Notification: PCN for RFA300960A backlight enclosure

- Subject of Change : Engineer design change for 0.96" TFT backlight enclosure
- Issue Date : 19 April, 2022
- Description : To improve the backlight to be fixed with the TFT panel, we strengthen the backlight design, FPC and the Frame structure.
- Effect of Change : RFA300960A and RJA30096 Series
- Appearance Difference : Yes
- Function Difference : No
- Planning Changing Time : Immediately after the current stock running out.

Frontside Appearance

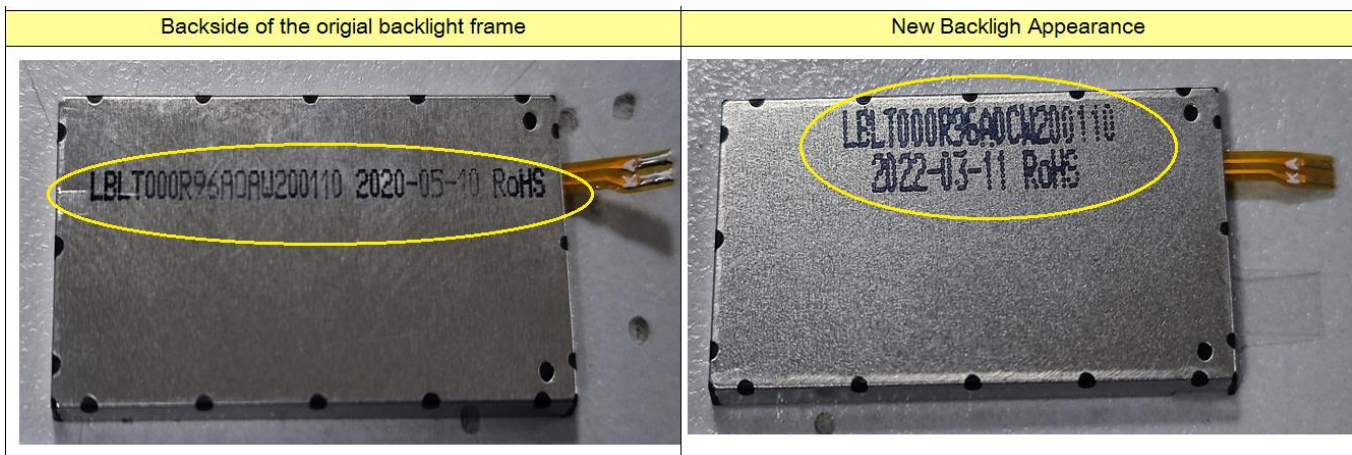
The front of the module is fixed by black tape
FPC with concaves

Backside Appearance

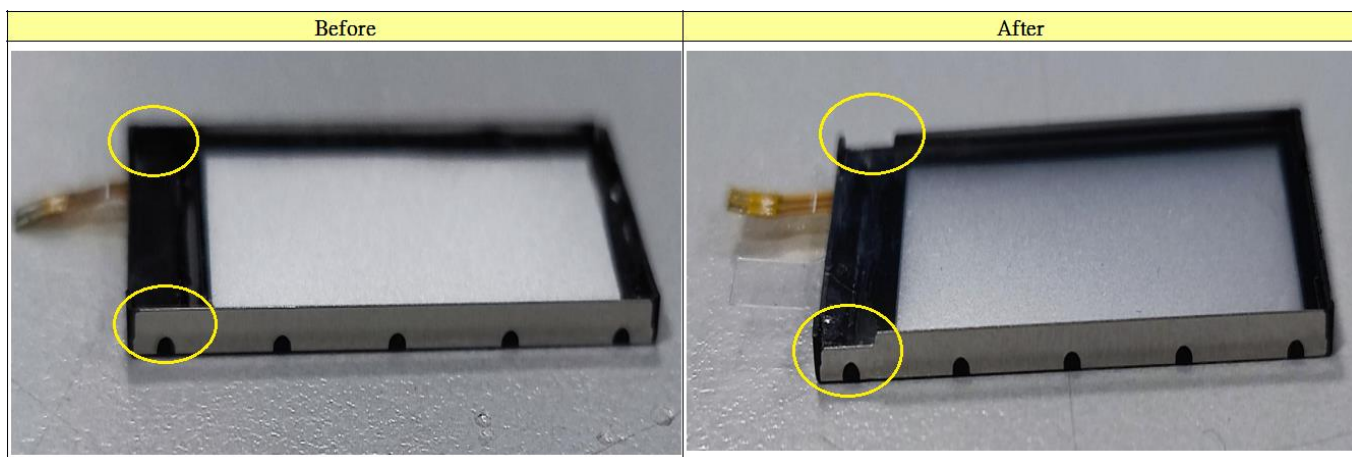
black tapes are folded to the back of the module
